NU2110 4' Firewood Holder

Addendum to Assembly Manual

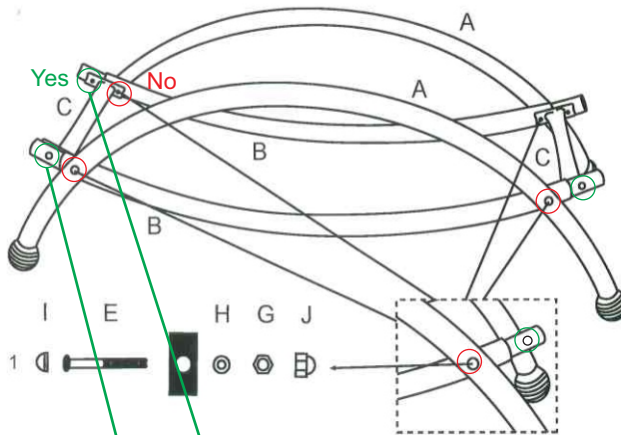
The drawing in the assembly manual was incorrect. The holes in the Base Sides (NUP4001) must assemble through the FIRST holes in the Bottom Frame (NUP4002) with the M8x100mm bolts (NUP4005) in all four places. Assembling as shown in the original manual drawing will result in the other holes being unable to align.

Please see the below corrected line art drawing and assembled picture.

Note:
Bolt should go through
OUTSIDE hole on both
sides of middle arc.

Correct:
(Both Sides)
